Major Projects
NSW Government

Re: Proposed Ryde Hospital Redevelopment Concept & Stage 1 Submission Amendment To Original submission (SUB-53912207)

Figure 1: MDCP Extent not clear – what is outline of level over indicate?

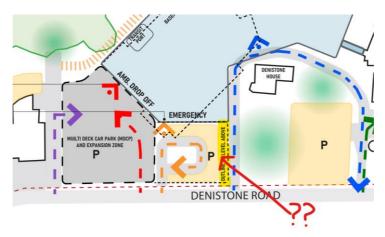
Also, could you please confirm a MDCP/structure will not be built over the emergency public access drop area. It is unclear based on the current documentation which states outline of level above? Refer figure 1 below.

Figure 2: Keeping MDCP in original location with an internal access road.

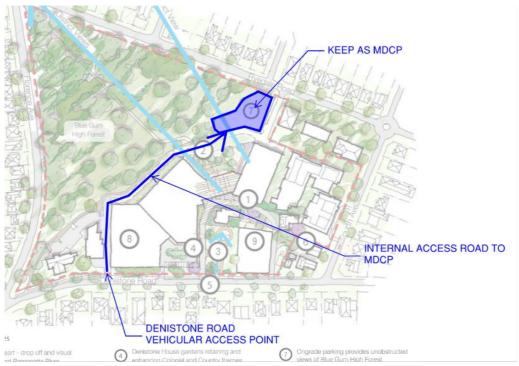
2. MDCP Location keeping original location: I appreciate the amount of public and council feedback regarding the original MDCP location adjacent to Rydedale Road (option 1). As the entrance to the car park would have been at ridge and is significantly residential. However could the location still be considered by making the vehicular access point to the MDCP option1 from Denistone Road as per the intent of this latest proposal. See below mark -up figure 2 showing an internal access road to the MDCP. The location of MDCP is not fronting residential properties and provides better access for pedestrians to the hospital main building. The current proposal is congested with public access to emergency, ambulance emergency and public parking. The below would at least spread out the activity of cars lessening the impact on Denistone Road while also considering Rydedale road residences. Please advise of this consideration to lessen the activity around Denistone Road and especially residential houses near the proposed MDCP location.

Figure 3: Location of my residence to emergency hospital entrance

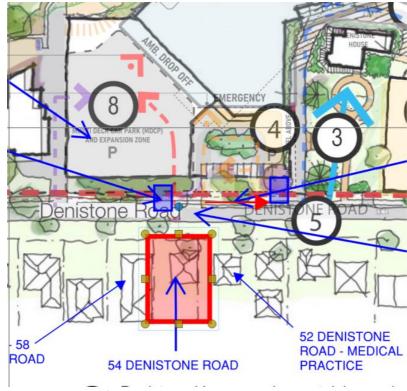
3. Driveway entry points directly opposite my residence: As previously commented on back in September 2022 as part of my submission. I note the emergency ambulance driveway/entry and public emergency drop off are still directly opposite my property. There has not been any attempt to move driveway entry points. Refer below, shaded red box is my house figure 3. I am worried by the amount of cars using these entrances at all times of the day and night. Currently there is no driveway entries at these locations. Also, I am worried about the additional noise impacts from public car drop off here. Two entry and exit points so close to each other seems excessive and they are concentrated directly opposite my front façade which has front bedrooms. Please advise if these can be shifted slightly as noted in my drawing mark-up over the revised concept architectural layout – enclosed mark-up.
